Perry Nuclear Power Plant
Docket Nos. 50-440; 50-441
SER Confirmatory Issue (54)
Permanent Dewatering System Testing

This letter and its attachments are provided in response to your staff's request for clarification, during a November 19, 1984 site visit, regarding SER Confirmatory Issue (54) on preoperational and periodic testing plans for the porous concrete subsystem of the permanent dewatering system. This letter supplements the information provided in our letter dated September 21, 1984 (PY-CEI/NRR-0114L). The clarifications are from the test procedure and are provided herewith as Attachments 1 and 2. Proposed FSAR changes related to the testing clarifications are provided as Attachment 3.

Figure 1

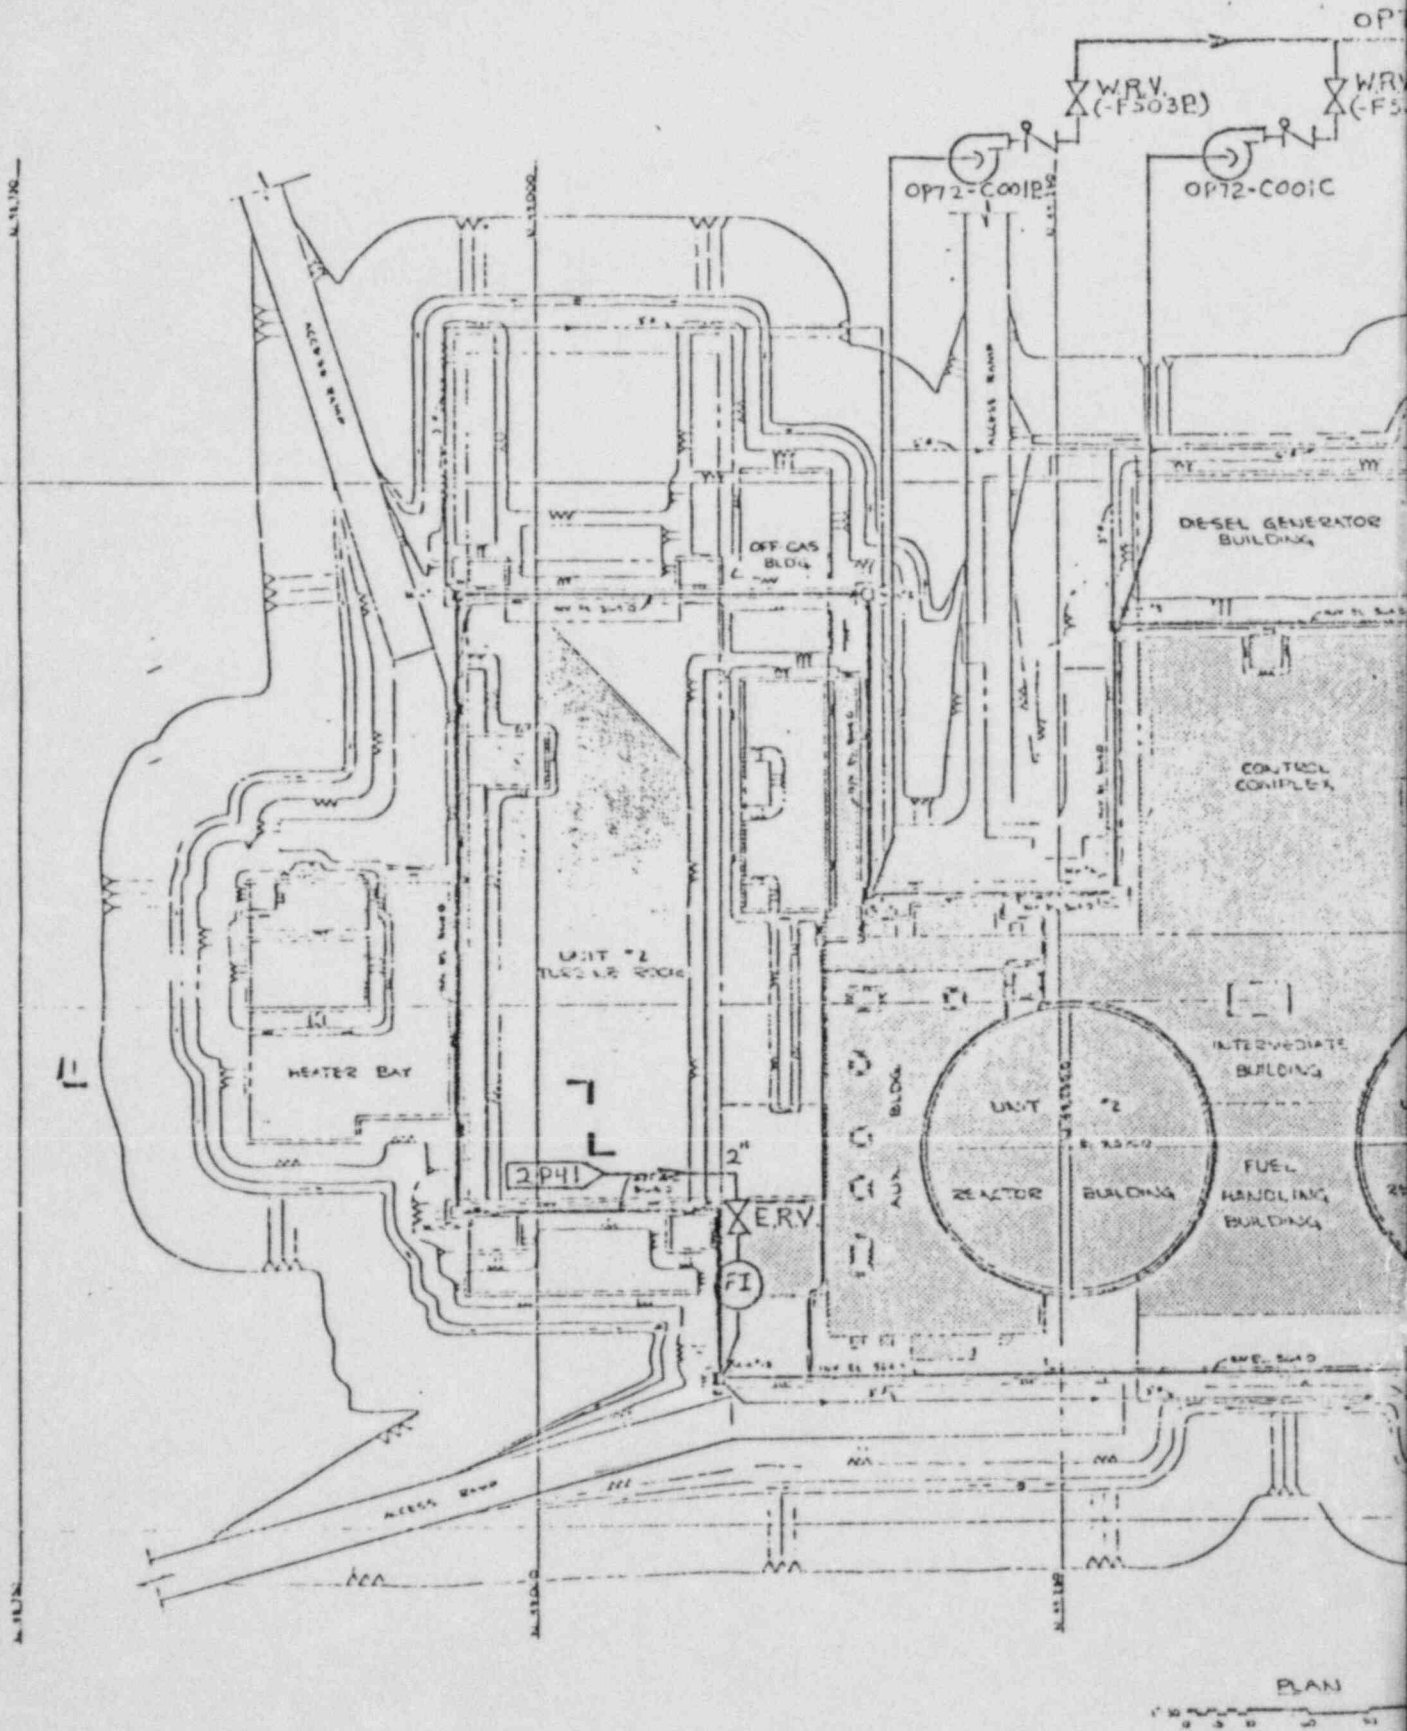
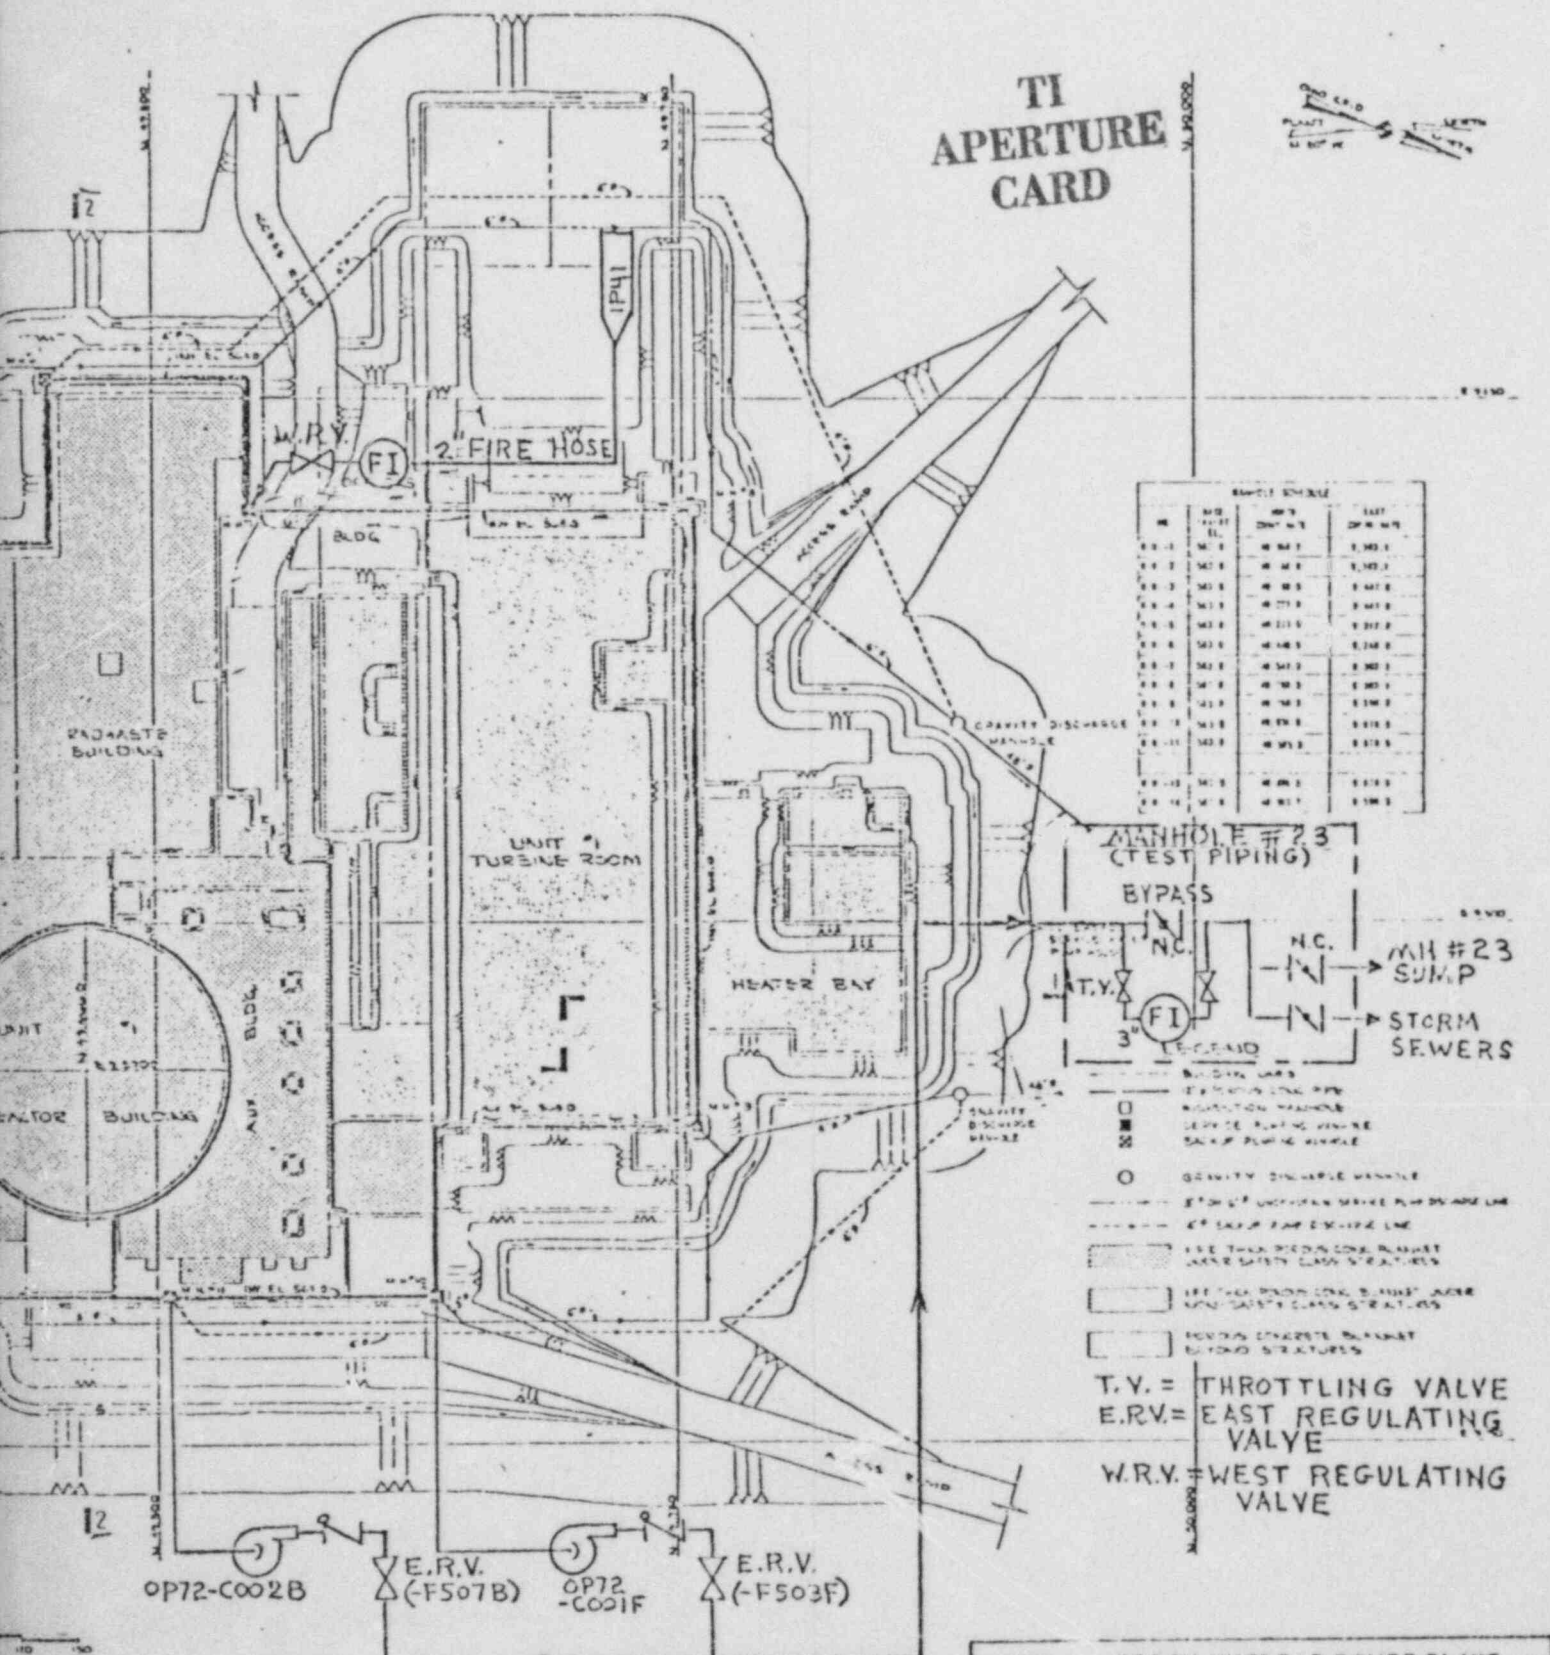
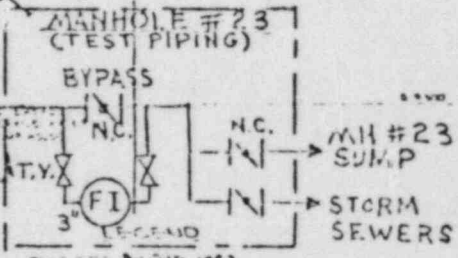
- a. Set up the water intake and discharge systems as illustrated in Figure 1 (sheet 5 of 6).

Figure 2
8502150488-02

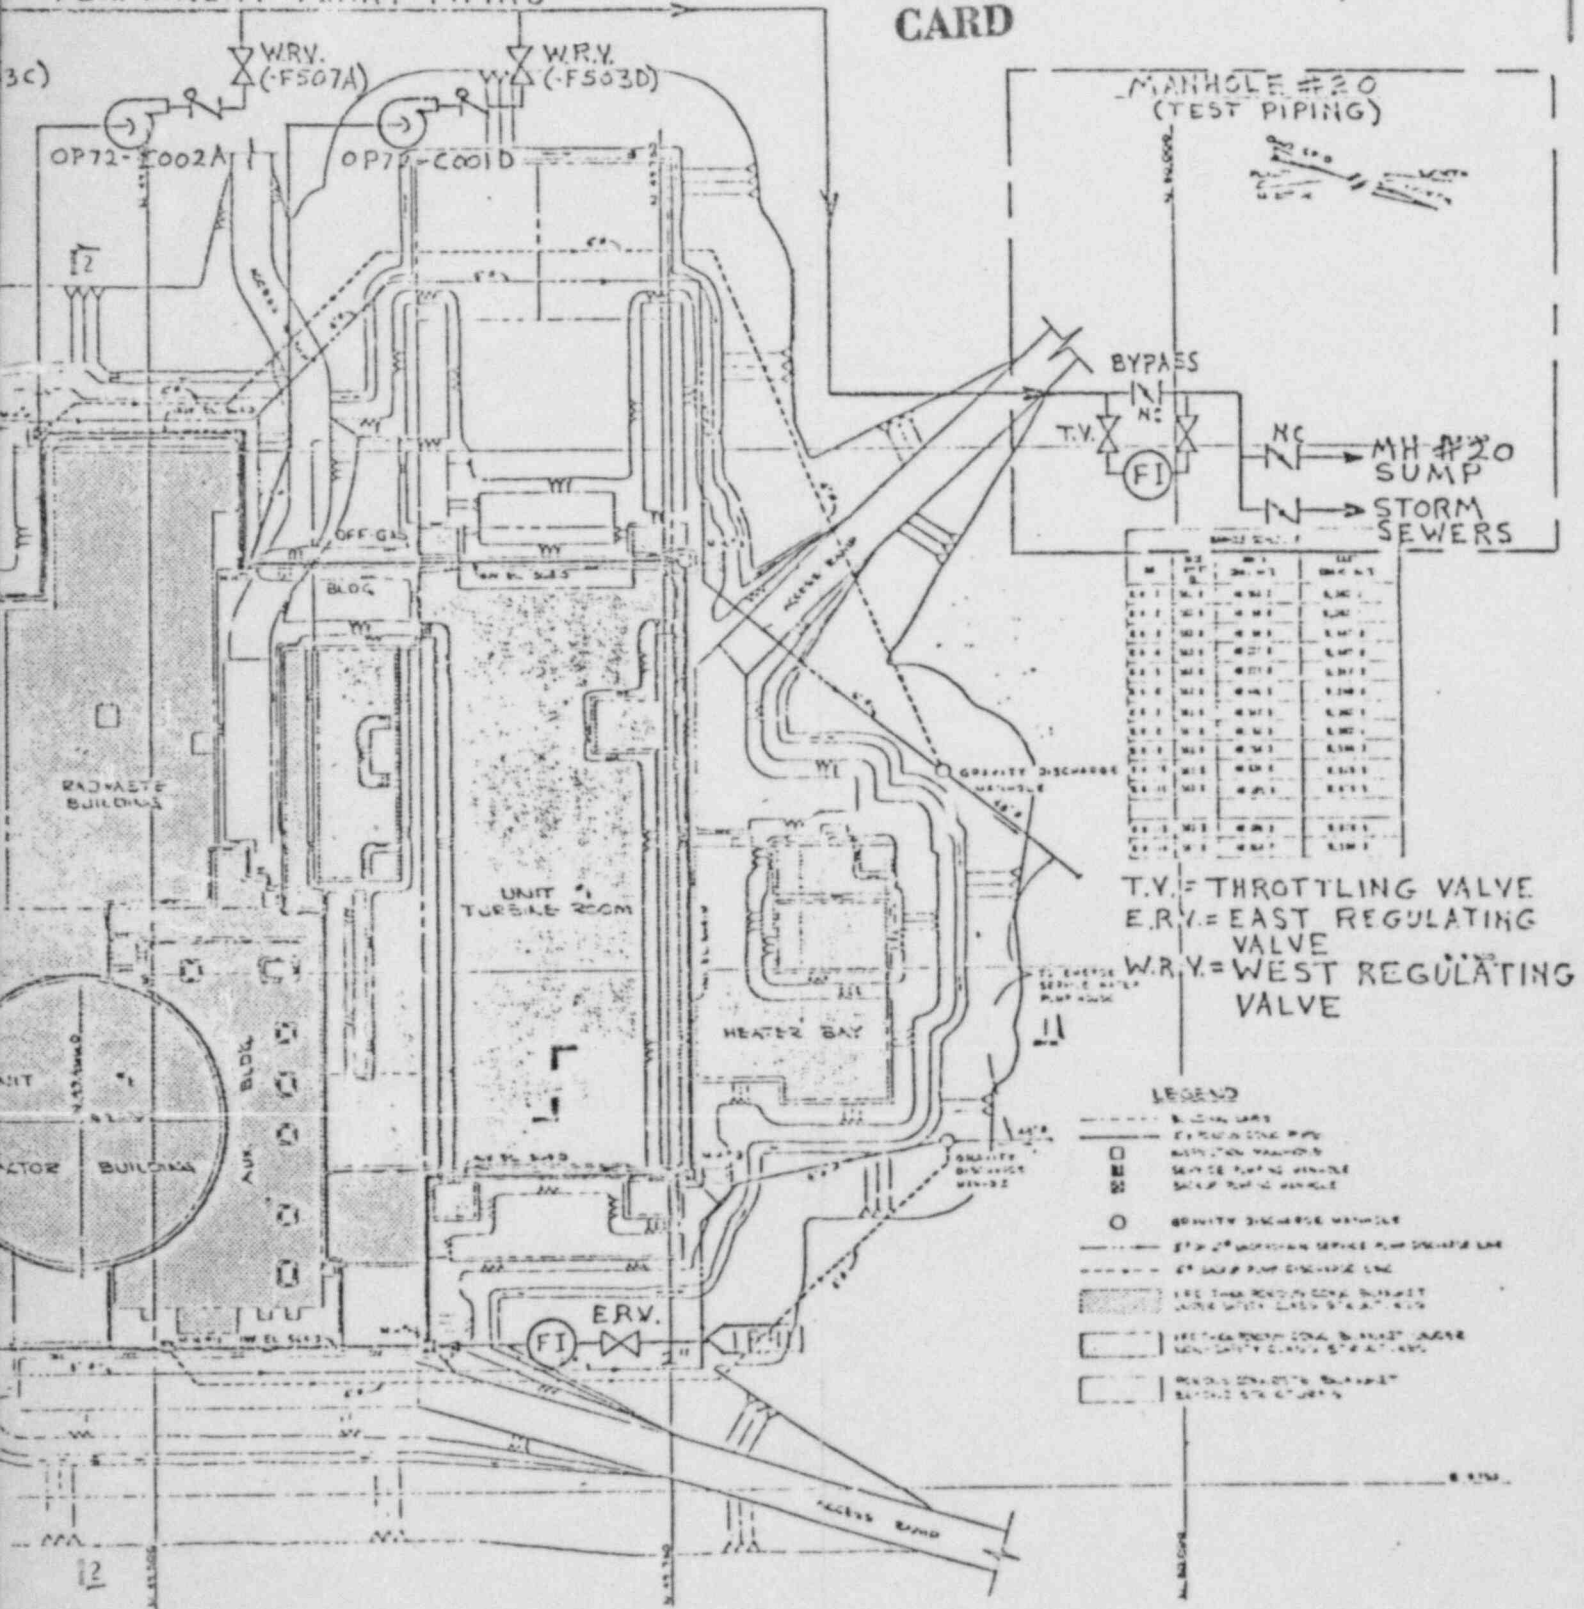
- i. Record final water level measurements in the manholes and piezometers.
- m. Record final supply and discharge flow rates.
- n. Repeat Steps 2a through 3m for a test with flow in the opposite direction. The water supply and discharge systems should be set up as shown in Figure 2 (sheet 6 of 6) with outflow measured in Manhole 20. Procedural steps will be the same as in the first test, except that references to "east" and "west" should be reversed.
